G.A.B. Limited (Extension)

10 February 2025

Structural Inspection Report

Observation-1: Prepared DEA report needs to be reviewed against lateral forces (Building -5).

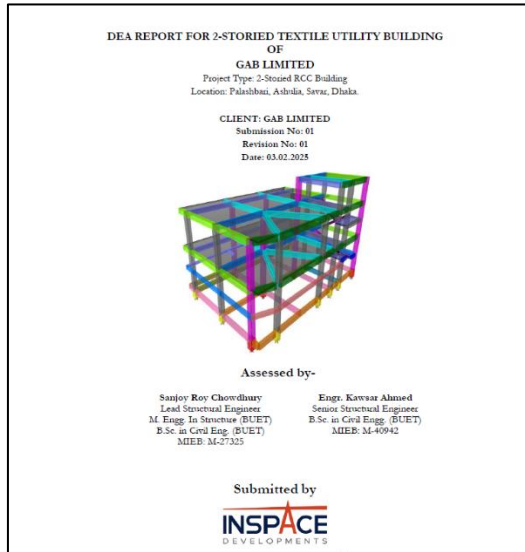
Description: A DEA report has been prepared for the two-storied Building 5. The prepared DEA report needs to be reviewed against lateral forces. Building engineer is required to submit the DEA report to the RSC for detailed review.

Observation-2: Prepared design report needs to be reviewed against lateral forces (Building -6).

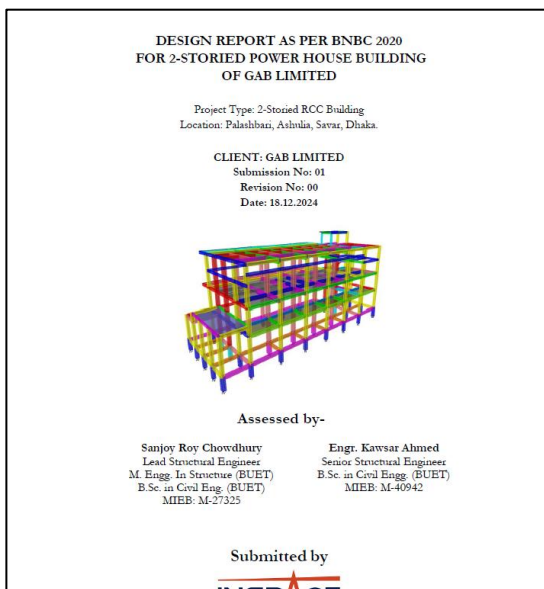
Description: A design report has been prepared for the three-storied Building 6. The prepared design report needs to be reviewed against lateral forces. Building engineer is required to submit the design report to the RSC for detailed review.

Observation-03: Possible vertical and horizontal extension. (Building 07).

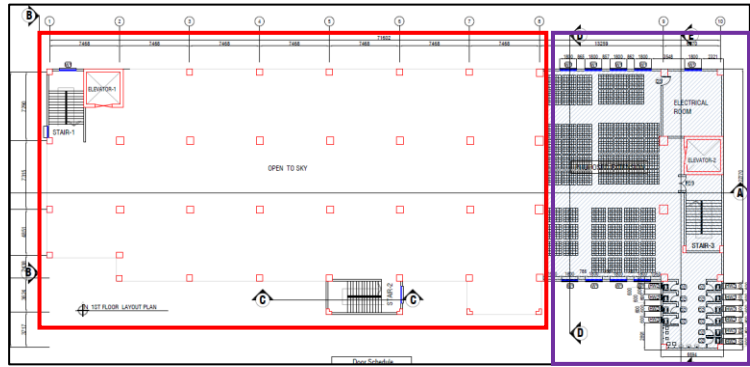
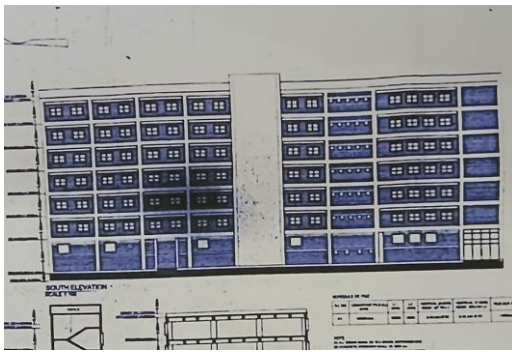
Description: The building has permit drawings for 7 storied, and currently, this is a single-storied. During the inspection, the proposed drawing with the design report was available on site, considering future vertical and horizontal extension.

Building engineer is required to submit the prepared Design report to RSC for review prior to conducting any vertical and horizontal extension.

Observation-4: Prepared design report needs to be reviewed against lateral forces (Shed -7).

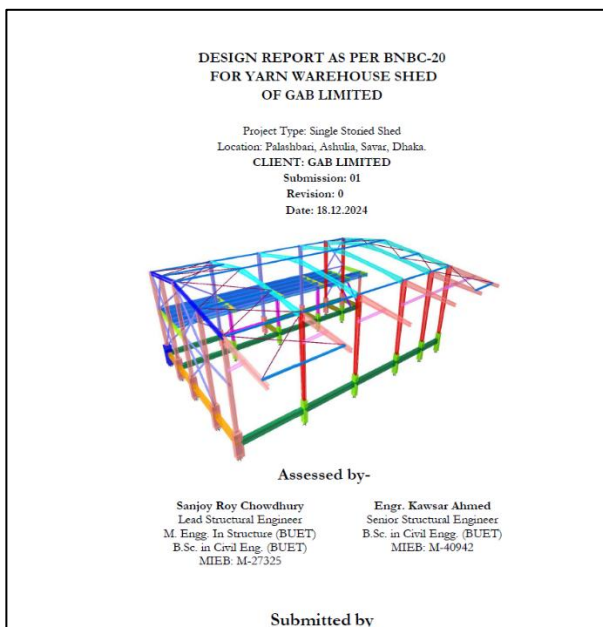
Description: A design report has been prepared for the single-storied Shed 7. The prepared design report needs to be reviewed against lateral forces. Building engineer is required to submit the design report to the RSC for detailed review.

Observation-5: Prepared design report needs to be reviewed against lateral forces (Shed -8).

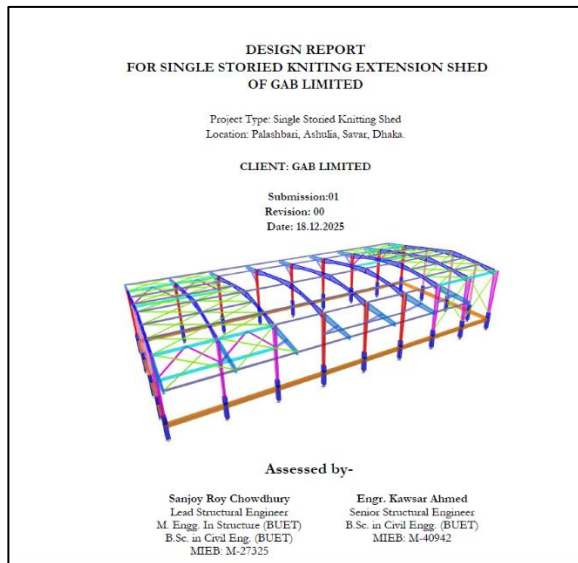
Description: A design report has been prepared for the single-storied Shed 8. The prepared design report needs to be reviewed against lateral forces. Building engineer is required to submit the design report to the RSC for detailed review.

Observation-6: Prepared design report needs to be reviewed against lateral forces (Shed-9).

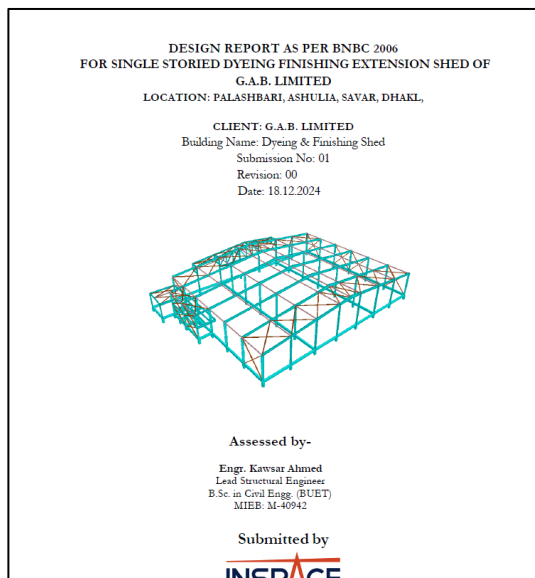
Description: A design report has been prepared for the single storied Shed 8. The prepared design report needs to be reviewed against lateral forces. Building engineer is required to submit the design report to the RSC for detailed review.

Observation-7: Prepared design report needs to be reviewed against lateral forces (Shed -10).

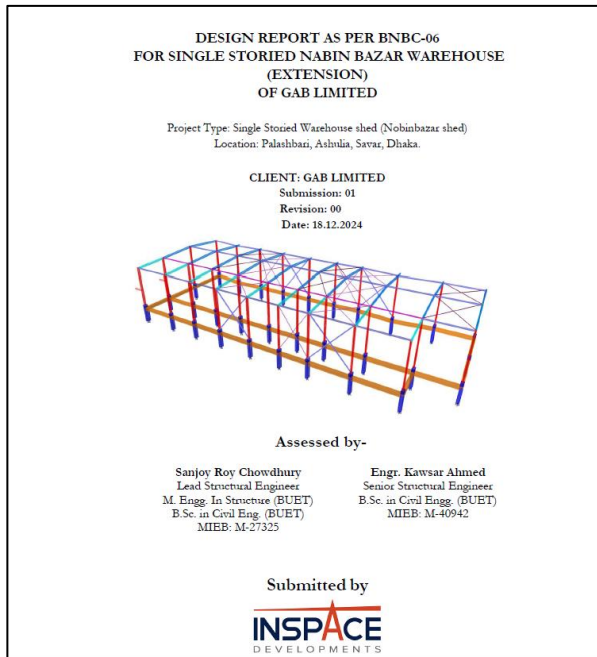
Description: A design report has been prepared for the single-storied Shed 8. The prepared design report needs to be reviewed against lateral forces. Building engineer is required to submit the design report to the RSC for detailed review.

Observation-8: Inadequate as-built drawings (Shed 11)

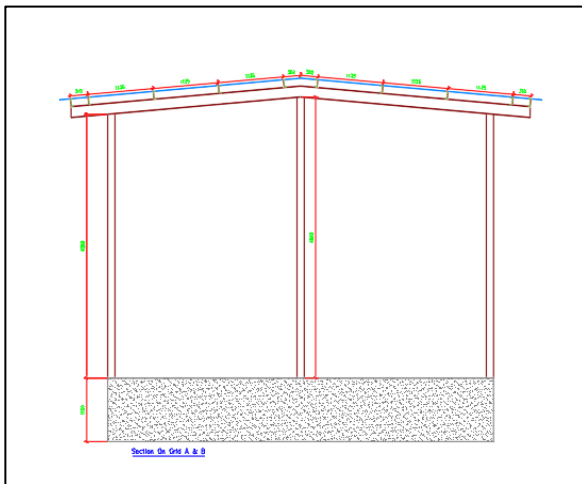
Description: In the available as-built drawing, only superstructure details were available. However, no structural details of the substructure, including the foundation and underground water reservoir, were available. The building engineer is required to update the drawing based on the as-constructed structure.

Observation-9: Incomplete lateral stability system. (Shed 11)

Description: During the inspection, no load transfer media along the long direction was observed. So, lateral stability in the long direction is incomplete. The building engineer is required to check the stability system as part of the EA for the existing structure.
